**CITY OF SUNNYVALE
REPORT
Planning Commission**

SUBJECT: **2009-0126:** Application for a property located at **1125 London Avenue** (at Vireo Ave.) in an R-0 (Low Density Residential) Zoning District.

Motion Design Review to allow an approximately 1,200 square foot second story addition to a single story home resulting in a Floor Area Ratio (FAR) of approximately 55% where 45% FAR may be allowed without Planning Commission review.

PROPOSED SECOND FLOOR PLAN
SCALE: 1/8" = 1'-0"

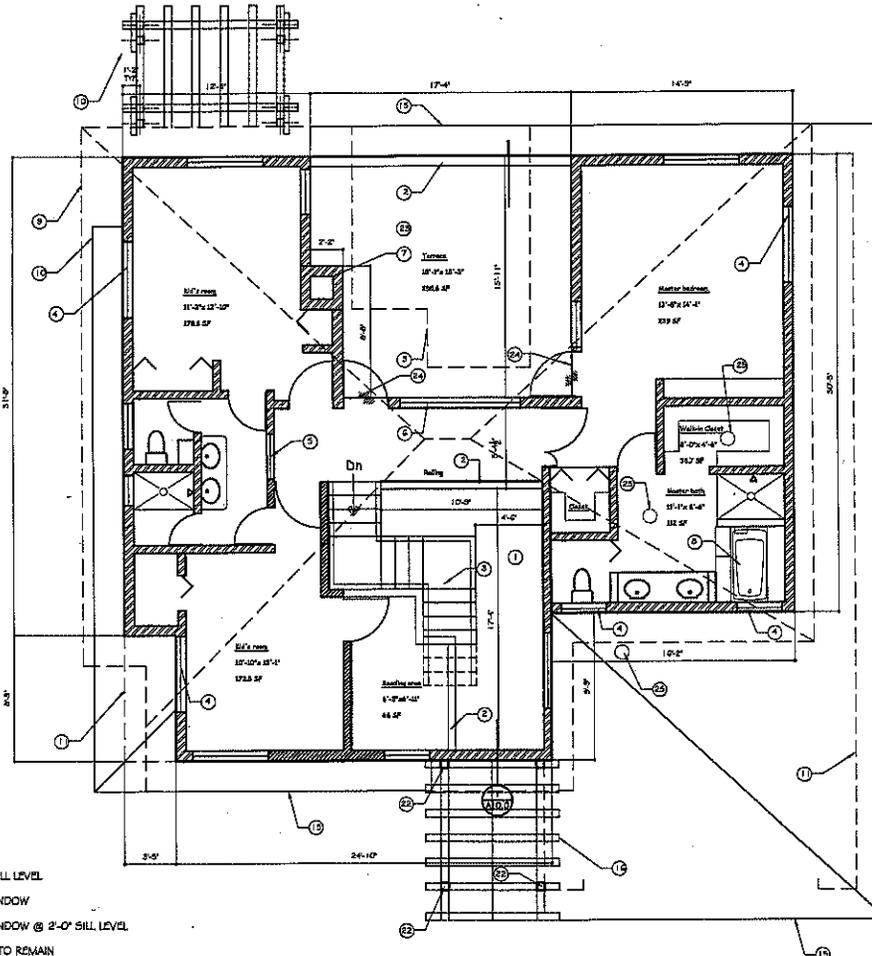
Visual Bulk and Mass: Staff finds that there are several design issues that make the proposed home visually bulky and massive along the streetscape and in relation to other homes found in the neighborhood. Although second floor setbacks comply with zoning standards, the second floor is almost 55% of the first floor where second floors of 35% or less are encouraged in the adopted Single Family Home Design Techniques. The large terrace adds to this visual bulk and would increase the second floor proportion to 67% if counted towards gross floor area. In addition, the home appears "boxy" with significant portions of the first and second floor walls that vertically line up, and extend to within 2 feet from the edge of the eave line.

Staff believes that there is opportunity to address the visual impact of the second story. First, staff recommends that the size of the second floor be reduced by 240 square feet, resulting in 50% FAR. This size reduction would allow for better compatibility with the size of other homes found in the neighborhood and is consistent with other recently approved two-story homes approved by the Planning Commission. Second, staff recommends that the size reduction be taken from the front and left sides (street-facing elevations) of the second floor. The intent is to reduce the appearance of the mass of the second story through additional articulation and setback of the second story.

Staff's recommended changes will result in significant redesign of the second floor. However, staff finds the proposed 921 square foot second floor to be sizable and that a size reduction can be reasonably accommodated by reducing the size of the bedrooms and/or terrace, and removing or reducing the reading room.

- A. The plans shall be revised as follows, subject to review and approval by the Director of Community Development:
 - a. The size of the second floor shall be reduced by 240 square feet, resulting in a maximum of 50% FAR and 43.5% second-story coverage.
 - b. The size reduction shall be taken from the front and left sides of the second floor, and shall result in increased setbacks.
 - c. Add architectural details to all elevations such as but not limited to shutters, awnings, decorative light fixture, and decorative window trim.
 - d. The entry shall be redesigned with thicker wooden posts or other details in proportion with the house.
- B. All existing unpermitted fences and accessory utility buildings shall be removed or modified to meet code requirements prior to issuance of final building permits, subject to approved FAR limitations. If

FRONT ELEVATION SOUTH
(EXISTING AND PROPOSED)

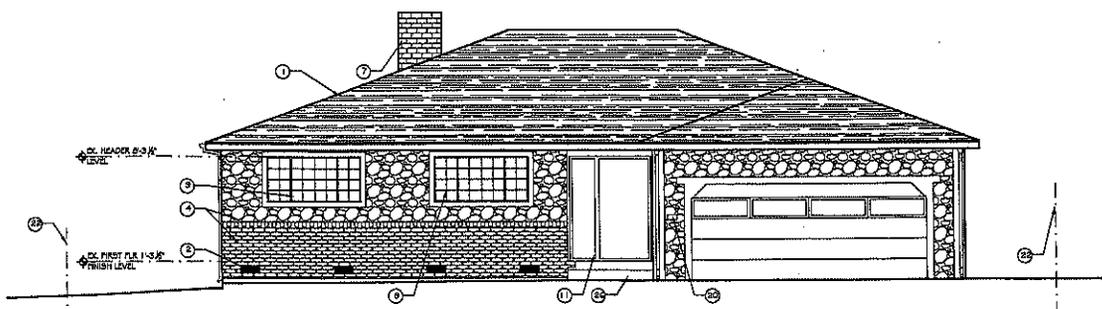
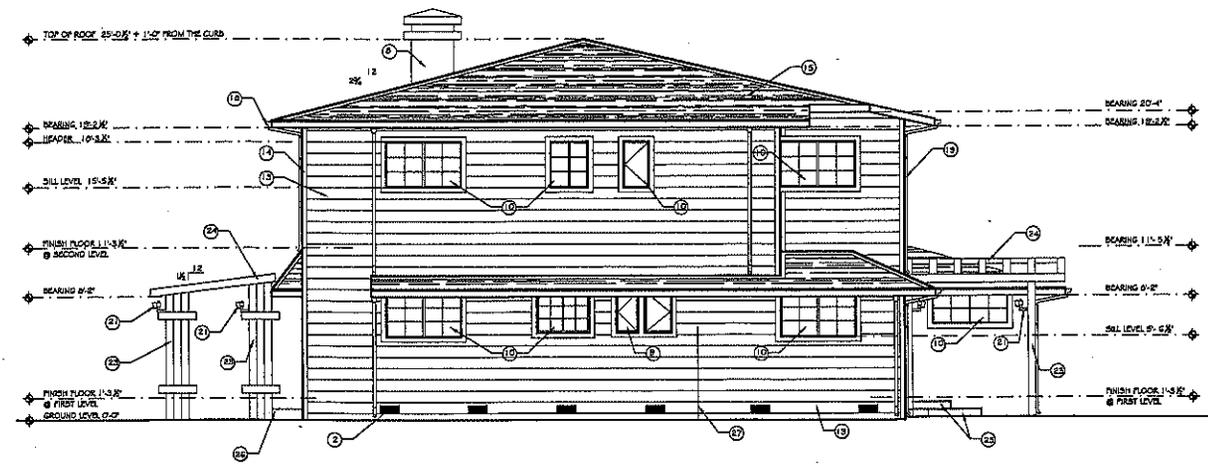
Architecture: The proposed home can be considered traditional in architectural style. The applicant has attempted to incorporate energy-efficient materials into the design of the home, including horizontal vinyl siding and a metal shingle roofing. Although wood siding and composition shingle roof materials are common for the neighborhood, the applicant has indicated that the proposed materials will have similar visual dimensions and textures. Staff recommends that the final colors and materials be subject to review by the Director of Community Development prior to issuance of final building permits. Staff further recommends the addition of finer details to the plan such as awnings, shutters, high-quality window trim and decorative lighting fixture to add visual interest to the walls (Attachment B, Recommended Conditions of Approval).

Entry Feature: The original design of the entry was too large for the size of the home and was not compatible with the architectural style. In response to staff's concerns, the applicant has significantly reduced the size of the entry and incorporated lighter elements, such as thinner posts and a trellis-style roof. However, staff finds that the current design is now too light in comparison to the scale of the home. Staff recommends that the entry be redesigned with thicker wooden posts with proportional detailing (Attachment B, Recommended Conditions of Approval). Having a proportional entry feature would help deemphasize the size and bulk of the home.
